# WHANGAMATA ACCESSIBILITY AUDIT REPORT

CCS DISABILITY ACTION

TAYLORED ACCESSIBILITY SOLUTIONS LTD

MAY 2014

**Figure 5: Proposed Mobility Space locations at Beach Access 5, Hunt Road**

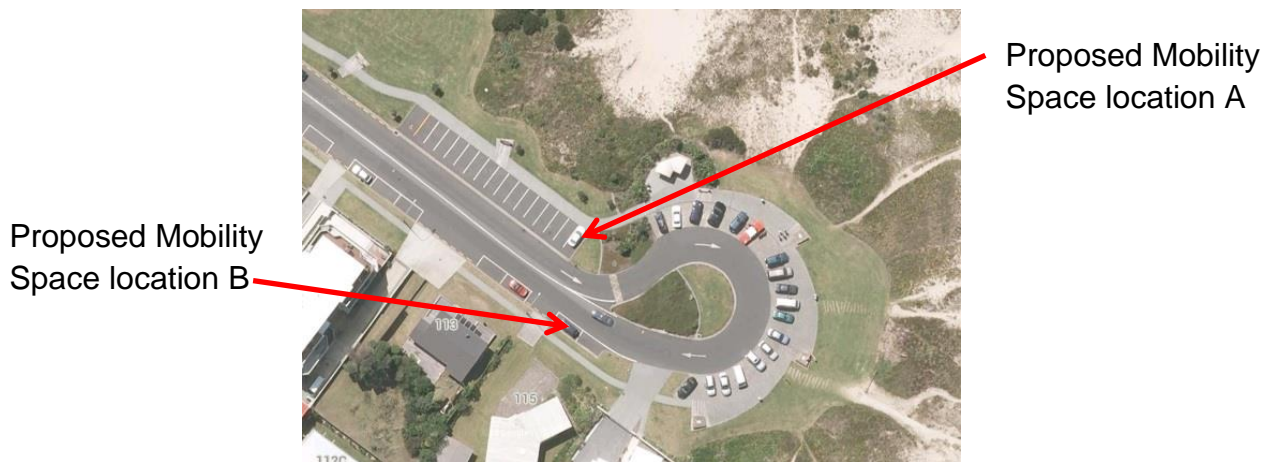
Mobility Space location A – Replace two 90° carparks with one Mobility Space. Installing a Mobility Space in this location will improve access to the boardwalk and the Public Toilets.

Mobility Space location B – Replace two parallel carparks with one Mobility Space. This will provide another option for Mobility Space users who prefer this type of parking. Users for this type include passenger side door users that need the extra space that the berm provides. Replacing two carparks will provide the length to rear loading vehicles to safely access the site without loading and unloading in the live traffic lane.

**Recommendation 4** Install two Mobility Spaces as shown Figure 5 at Beach Access No.5 on Hunt Road.

**Figure 8: Mobility Space with blue surfacing design**

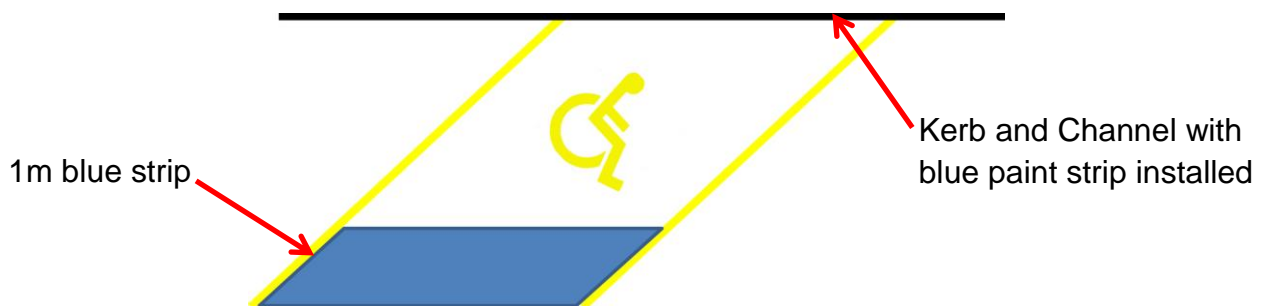
While full blue coverage is preferred for marking mobility parking spaces, in the interest of maintenance and costs, consideration could be given to only partially colouring the mobility space as shown in Figure 8.

A 1m strip for the length of the road edge of the carpark will provide visual notice to road users, reduce installation costs, and reduce the need for repair when replacing kerb and channel etc.

**Recommendation 10** Continue the programme to mark Mobility Spaces with blue surfacing. Installing blue marking as per figure 8 will aid with maintaining a non-slip surface with the colour of both the surface and the marking to comply with Land Transport Rule: Traffic Control Devices 2004.

**Figure 10: Port Road/Ocean Road crossing point.**

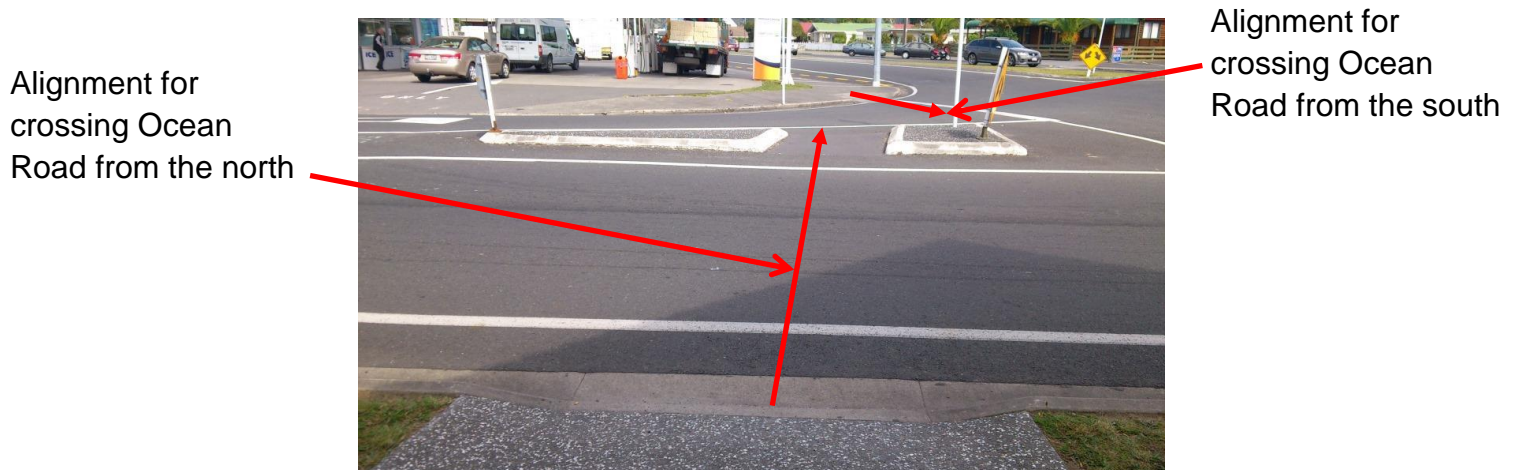
The kerb ramps crossing Ocean Road are not in alignment and have grades of 1 in 6.9 (14.5%) for the NE corner and 1 in 7.5 (13.3%) for the SE corner. Alignment is critically for visually impaired users and this is discussed further in Section 9: Tactiles.

Replacing the grade of the NE corner kerb ramp with a maximum grade of 1 in 14 (7.1%) in the same location will save the need for changing the splitter island. Correct the alignment by re-locating the kerb ramp on the SE corner only.

**Recommendation 14** Replace the kerb on the NE corner of Port Road/Ocean Road intersection crossing Ocean Road to a maximum grade of 1 in 14 (7.1%). Re-locate the SE corner of the same intersection crossing Ocean Road to the correct alignment and with a maximum grade of 1 in 14 (7.1%).

**Figure 17: Seal edge join after re-sealing**

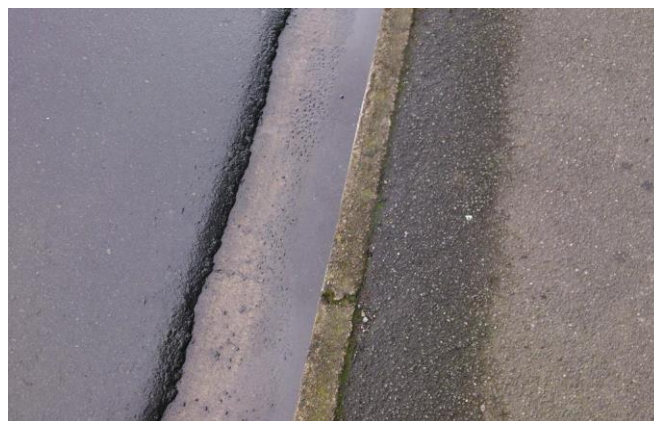
Re-sealing the carriageway can create a small lip where joining the kerb channel. This can require a wheelchair user to stop in the channel before negotiating the barrier. Milling the seal edge before re-sealing can eliminate this problem.

**Recommendation 23** Adopt the practise of milling seal edges at the join of the seal and the kerb channel, especially at areas where a flush kerb cut down is present, in maintenance contracts.

Figure 34: Hetherington Road

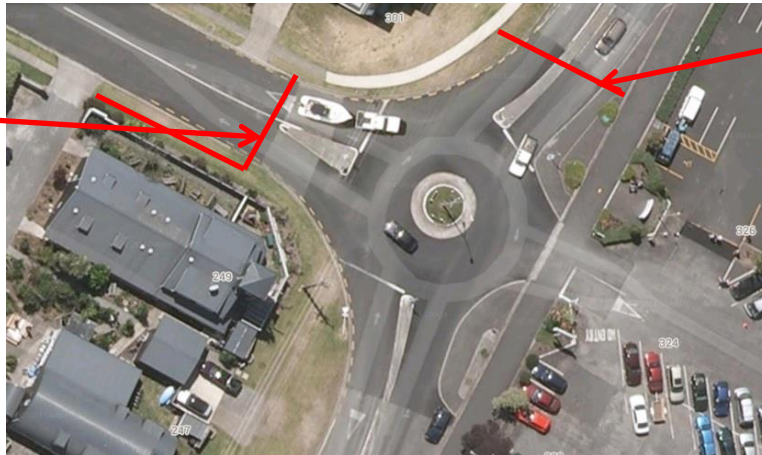
A crossing opportunity at this intersection will provide a safe connection from Rutherford Road to the footpath on Hetherington Road.

The ADT volume for Hetherington Road is approx. 2139 veh./day so it is highly likely kerb ramps will be sufficient, but a calculation using the Pedestrian Crossing Facilities Calculation Spreadsheet will determine the most suitable crossing facility.

**Recommendation 50** Use the Pedestrian Crossing Facilities Calculation Spreadsheet to determine the best pedestrian crossing facility at the Hetherington Road/Rutherford Road intersection.

**Recommendation 51** Once Recommendation 49 is completed, install a pedestrian crossing facility at the Hetherington Road/Rutherford Road intersection.

**Figure 36: Ocean Road/Lowe Street intersection**

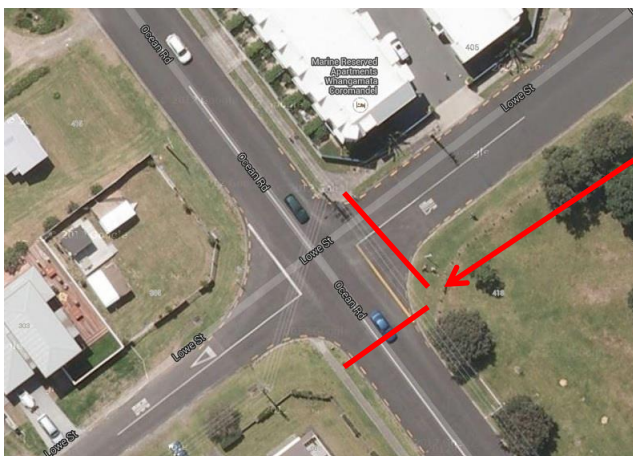
The footpath changes sides at Lowe Street, switching from the north side of Ocean Road to the south side. Installing a refuge island on Ocean Road at this intersection will provide connection between the footpaths as well as managing traffic speed on

Ocean Road. Install kerb ramps on the SE corner for crossing both Ocean Road and Lowe Street, and a kerb ramp on the SW corner for crossing Ocean Road.

**Figure 43: Footpath west and east of Tukere Drive**

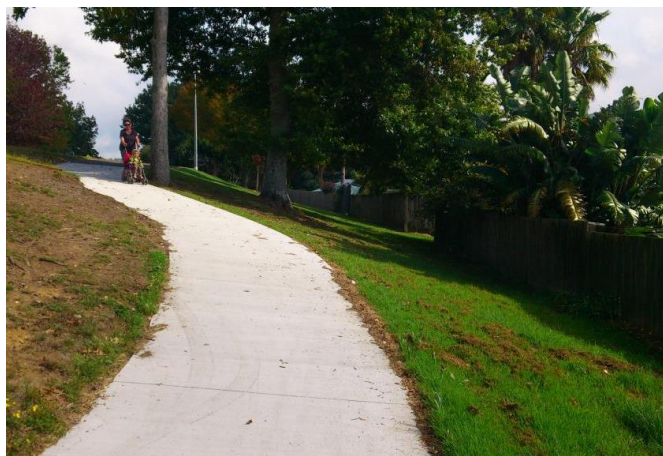
- West of Tukere Drive – 1 in 8 (12.5%); and
- East of Tukere Drive – 1 in 11 (9.1%)

Re-grading the footpath to a maximum of 1 in 14 (7.1%) will improve safety as grades greater than 1 in 12 (8.33%) can cause users to tip out.

**Recommendation 63** Re-grade the footpath west and east of Tukere Drive to a maximum grade of 1 in 14 (7.1%).
